UNITED STATES PATENT AND TRADEMARK OFFICE

APPLICATION NO.	FILING DATE	FIRST NAMED INVENTOR	ATTORNEY DOCKET NO.	CONFIRMATION NO.
10/777,943	02/12/2004	Toshiharu Watanabe	44471/297401	5357

Office Action Summary

DETAILED ACTION

FIG.2

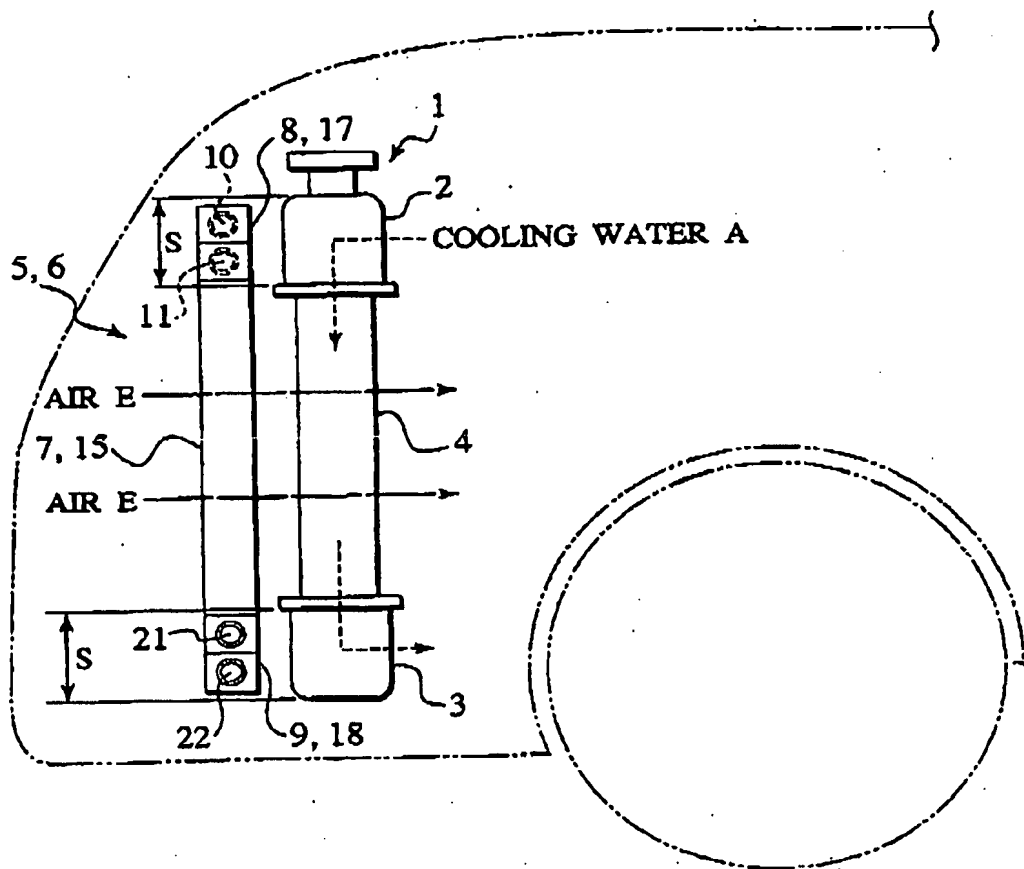
4. Replacement sheets including the required corrections for Figures 1 and 2 were received on December 21, 2006. These drawings are hereby approved.

5. Receipt and entry of the amended abstract filed on March 1, 2007 is hereby acknowledged.
6. The disclosure is objected to because of the following informalities: oil-conducting passages 17 and 18 (as per Figures 1 and 2 as well as the original claims corresponding thereto) which contain NO refrigerant are inappropriately referred to as "refrigerant passages" on pages 13 and 14 of the specification.

9. Claims 2, 3, and 11 are rejected under 35 U.S.C. 112, second paragraph, as failing to set forth the subject matter which applicants regard as their invention. Evidence that claims 2, 3, and 11 fail to correspond in scope with that which applicants regard as the invention can be found in the originally filed claims as well as in Figures 1 and 2. In those papers, as well as on pages 13 and 14 of the originally filed specification, applicant has disclosed ONLY oil to be passing through “refrigerant” passages 17 and 18, and this statement indicates that the invention is different from what is defined in the claim(s) because there is NO oil flowing through “refrigerant” passages 17 and 18.

Where applicant acts as his or her own lexicographer to specifically define a term of a claim contrary to its ordinary meaning, the written description must clearly redefine the claim term and set forth the uncommon definition so as to put one reasonably skilled in the art on notice that the applicant intended to so redefine that claim term. *Process Control Corp. v. HydReclaim Corp.*, 190 F.3d 1350, 1357, 52 USPQ2d 1029, 1033 (Fed. Cir. 1999). The term “refrigerant passages” in lines 9 and 14-15 of base claim 11 is used by the claim to mean “oil-conducting passages” as per Figures 1 and 2 while the accepted meaning is “refrigerant-conducting passages.” The term is indefinite because the specification does not clearly redefine the term and this term appears to be merely a typographical error carried over from pages 12 and 13 of the specification which use this same term but disclose the corresponding passages 17 and 18 as carrying oil, not refrigerant.

Appropriate correction is required.
